Project: San Angelo ISD Paging Upgrade (RFP #26-008)

Subject: Addendum 01

TECHNOLOGY ITEMS FOR ADDENDUM 01

FLOOR PLAN - AUSTIN
PROFESSIONAL LEARNING
(PL)

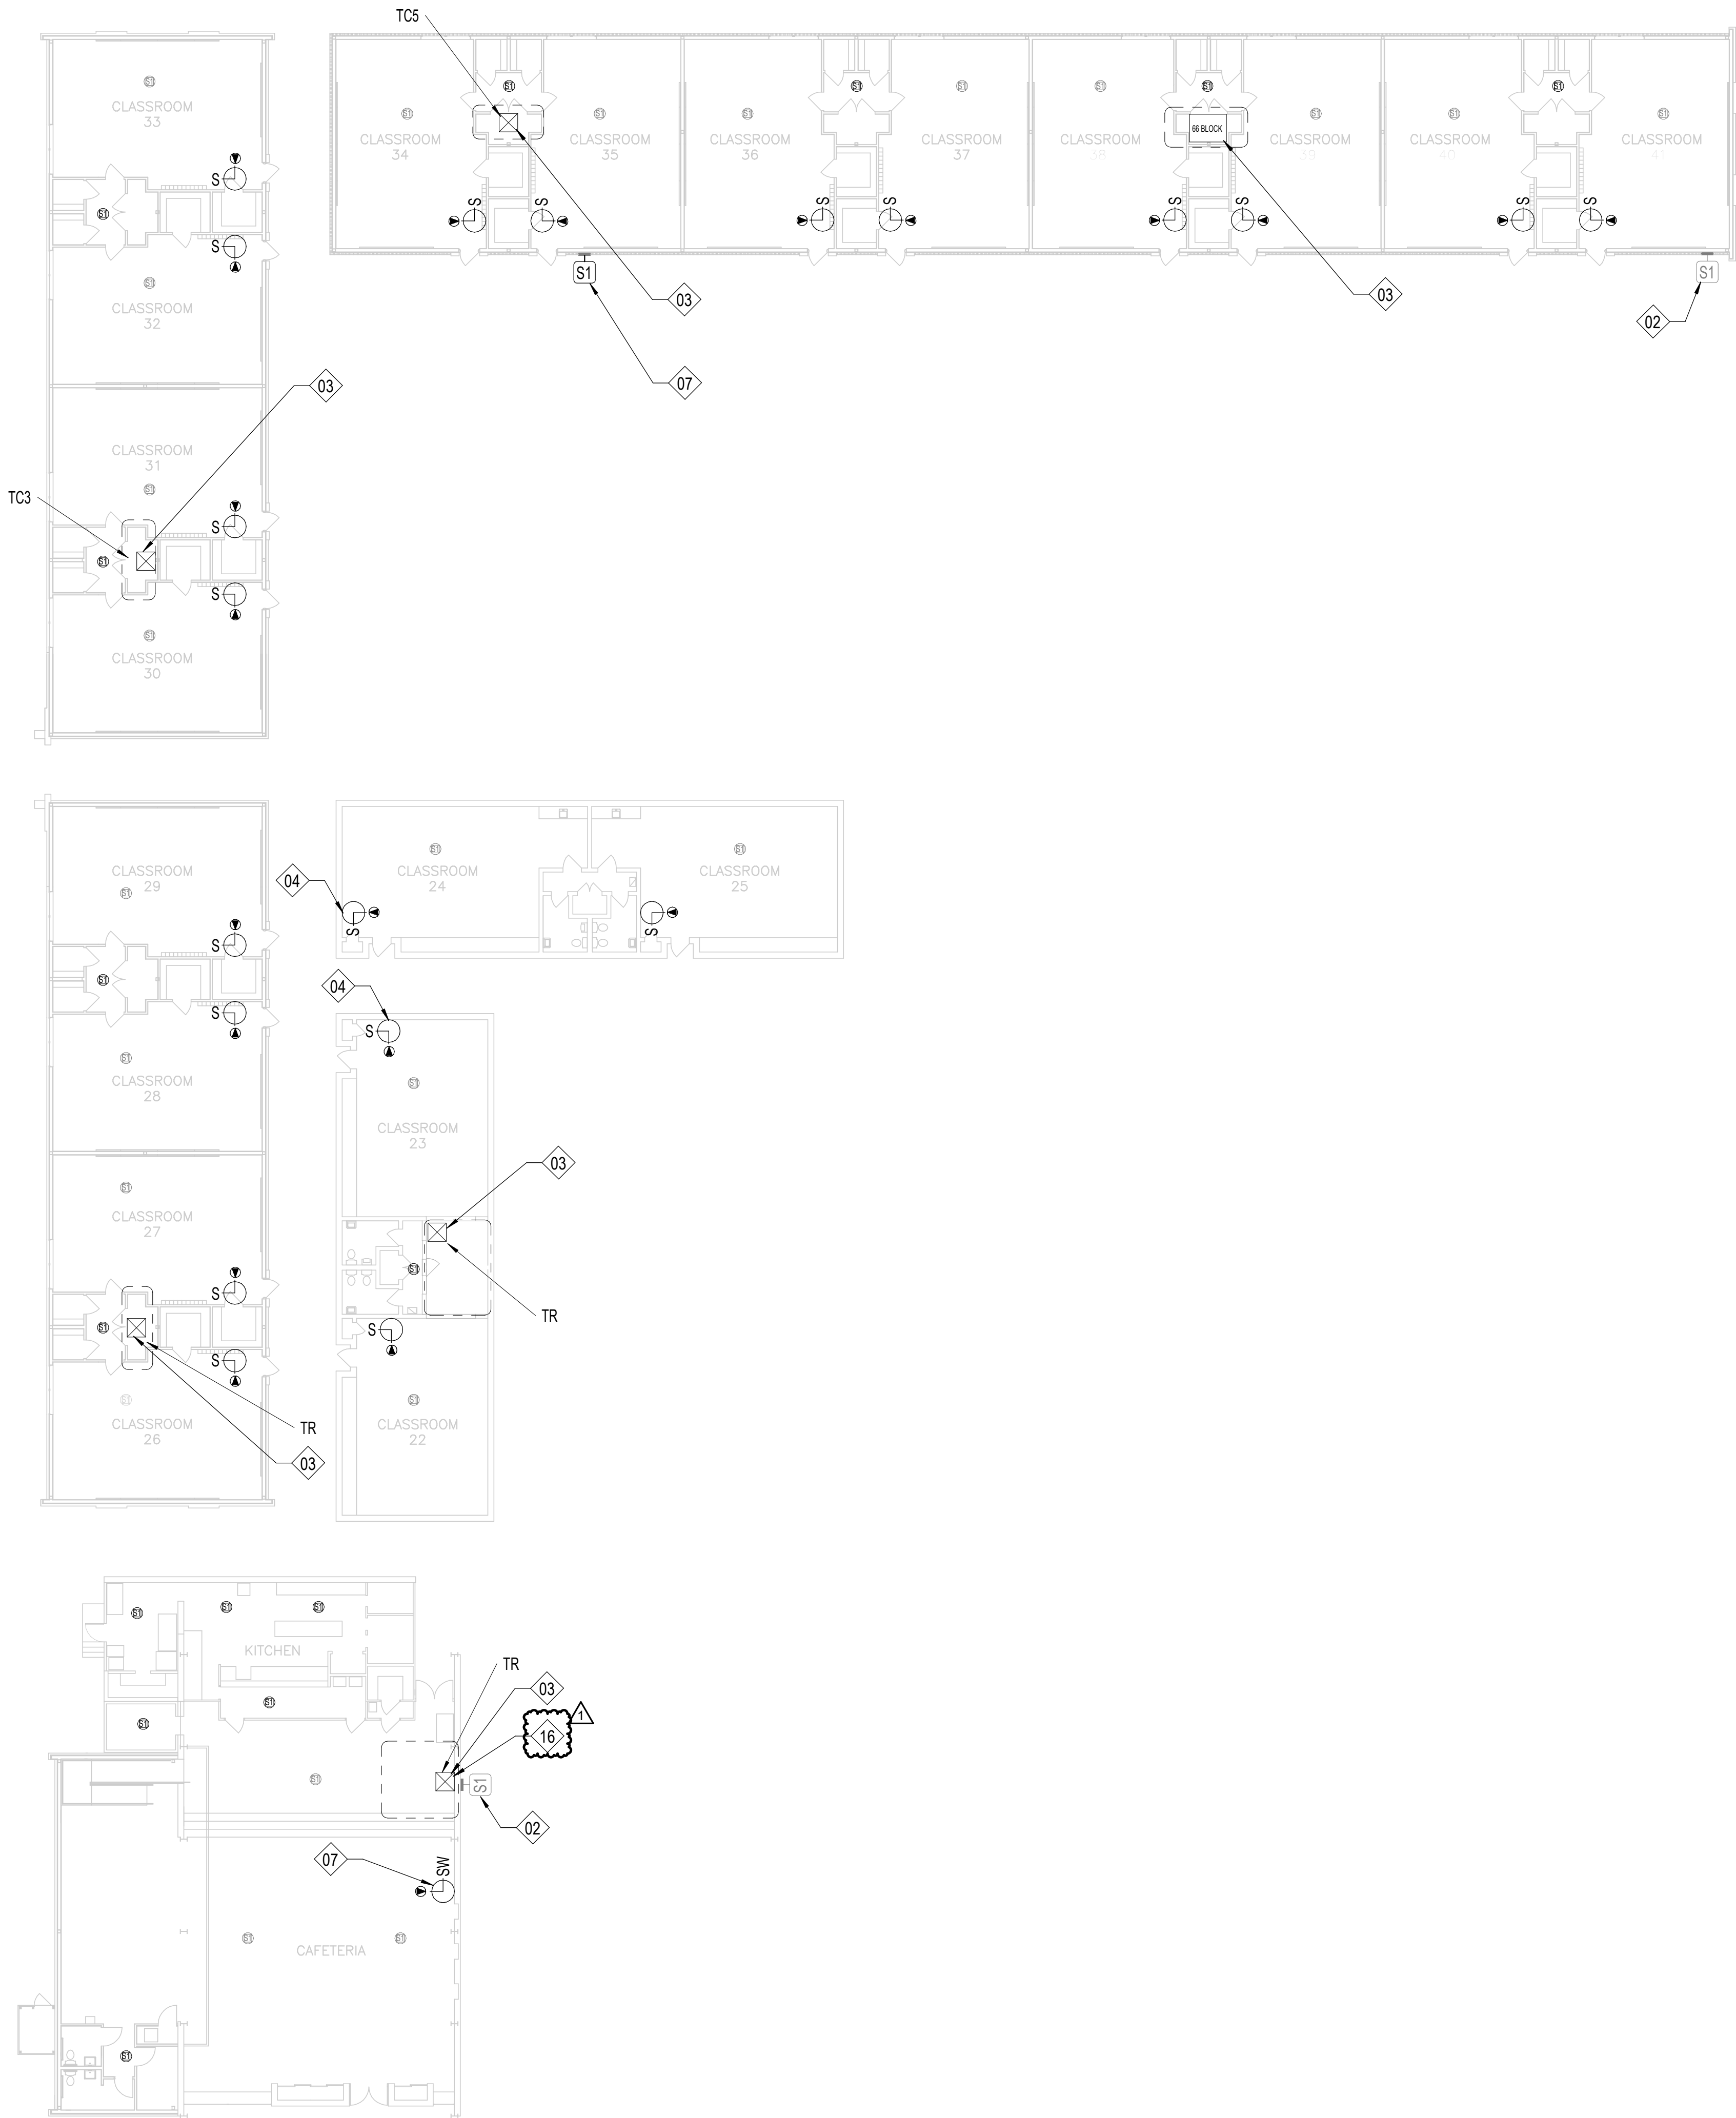
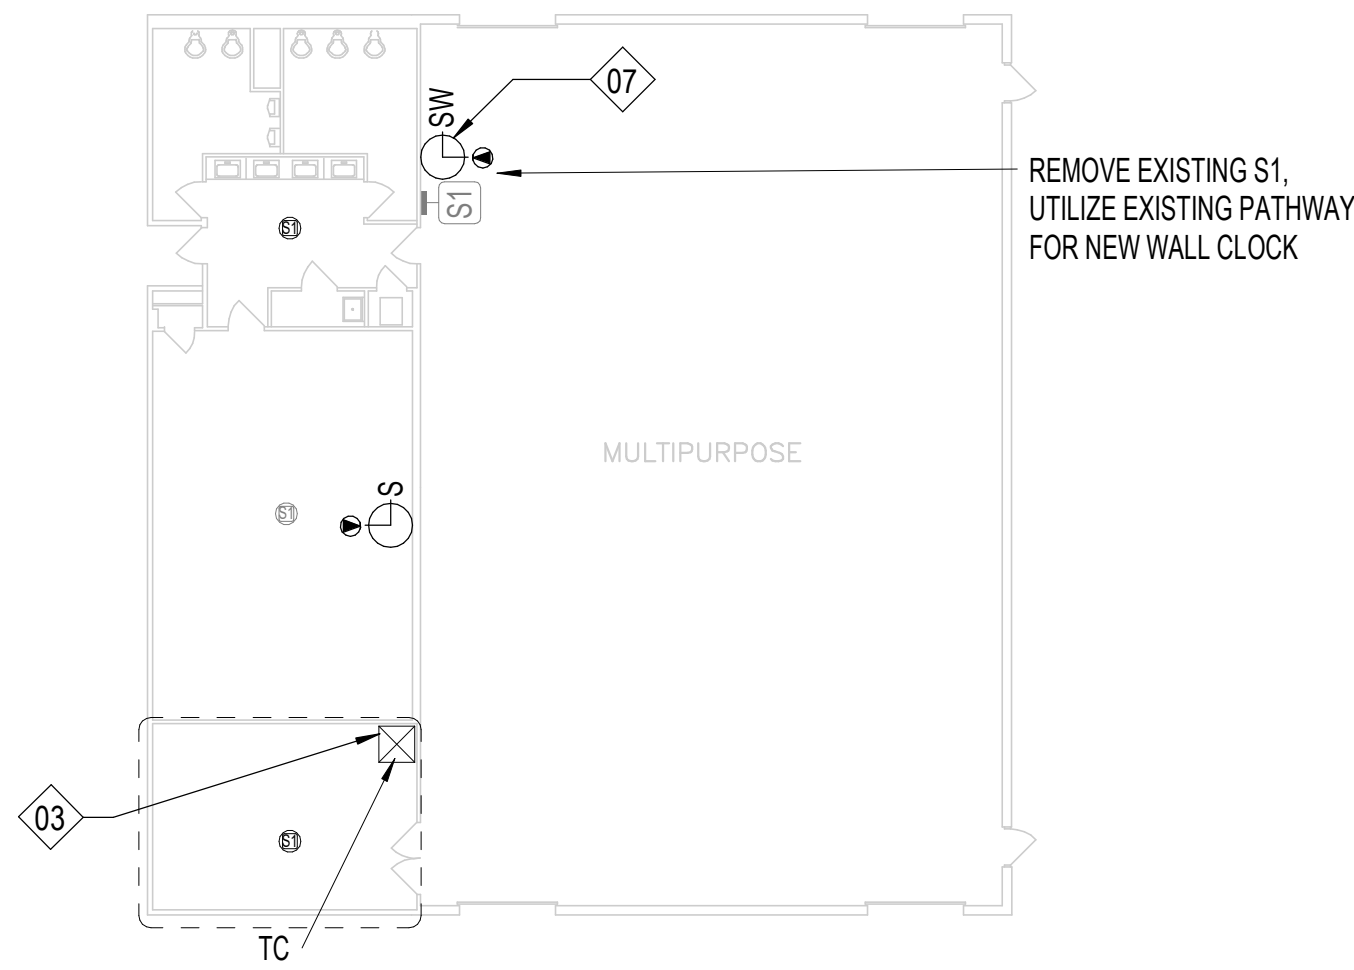
ADD No 1, Tech. Item 38: To the Drawings, Sheet T137, "FLOOR PLAN - AUSTIN PROFESSIONAL LEARNING (PL),"

- 1) Added halftone speaker clarification to Sheet Notes.
- 2) Added paint/finish clarification to Sheet Notes.
- 3) Clarified high-ceiling lift requirement item in Sheet Notes.
- 4) Modified/consolidated Keynote 16/17.
- 5) Added seal missing from title block.

1 TYPICAL CLOCK MOUNTING DETAILS
1301 NTS

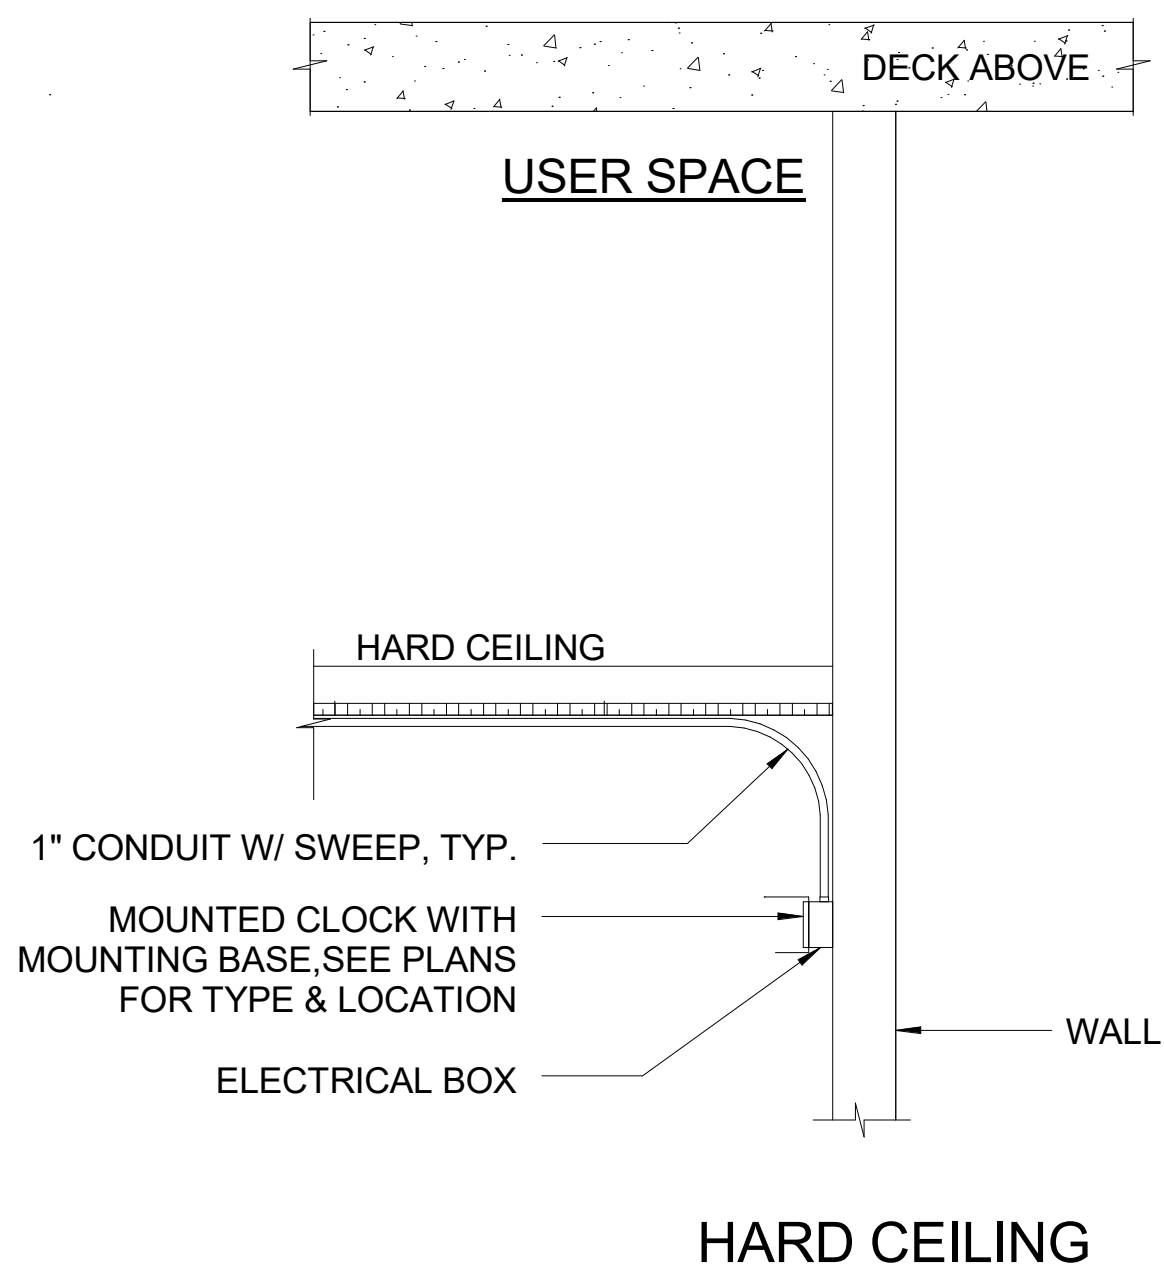
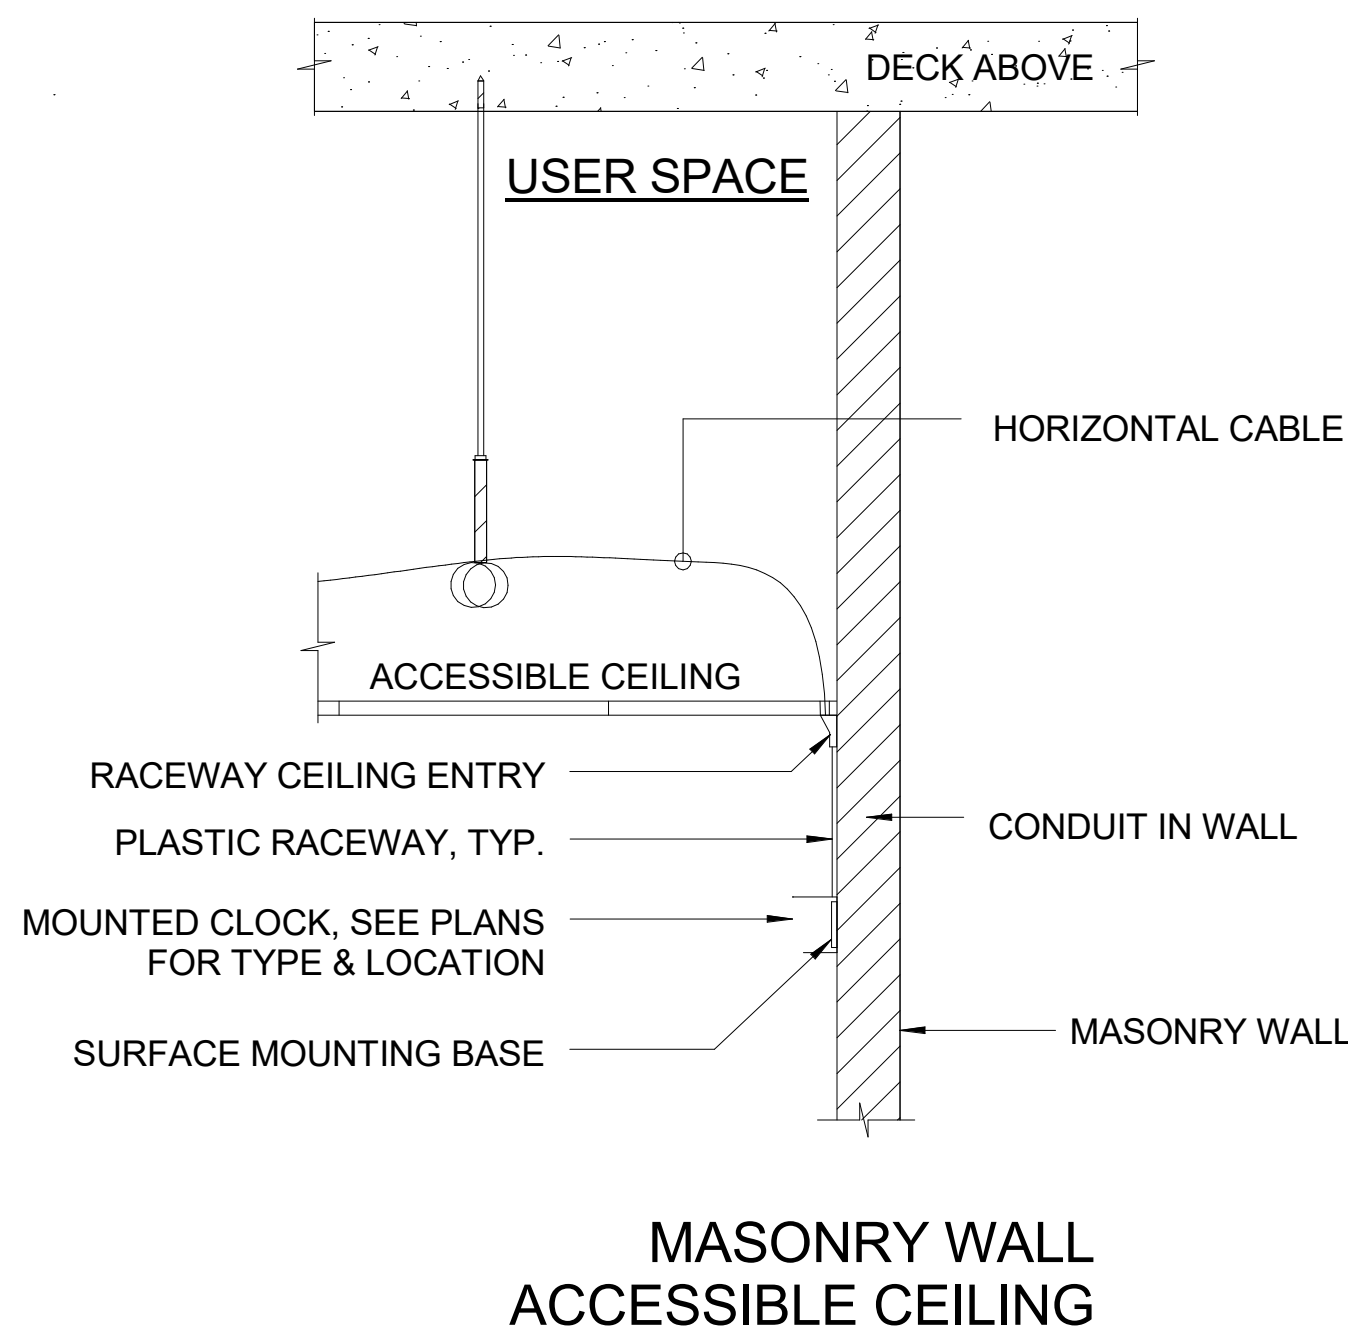
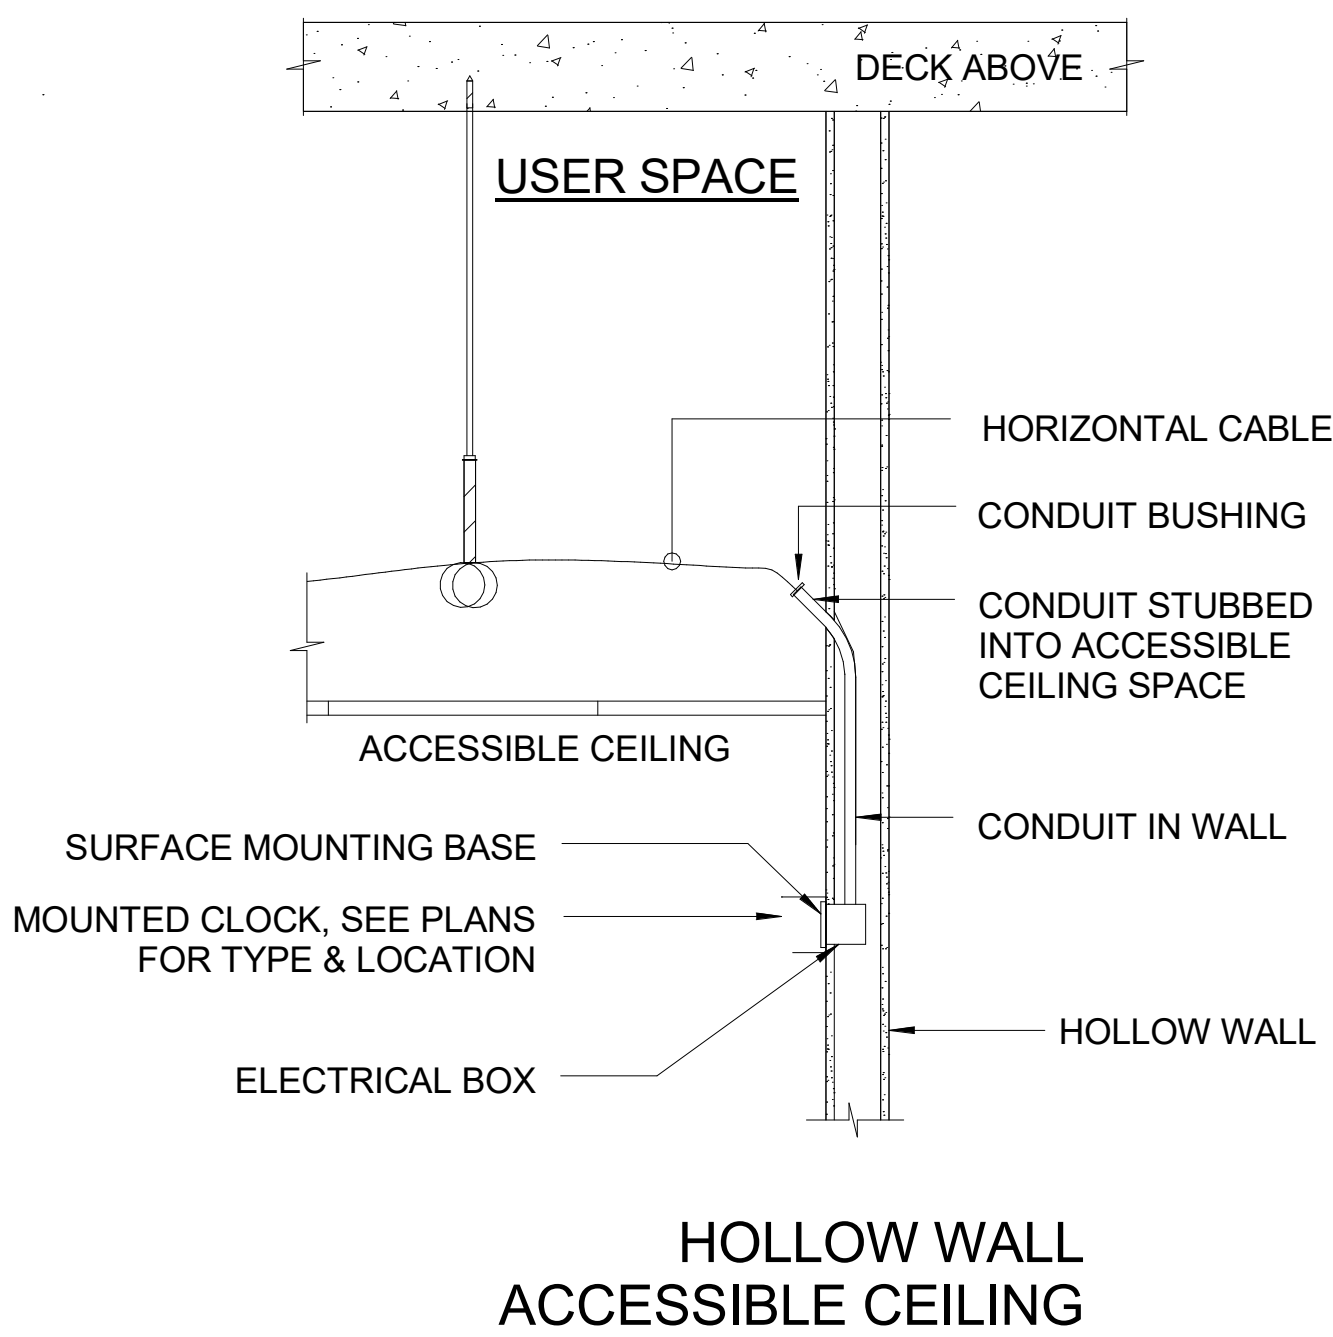
ADD No 1, Tech. Item 40: **To the Drawings, Sheet T501, "TELECOM - DETAILS,"**

- 1) Added sheet in its entirety.
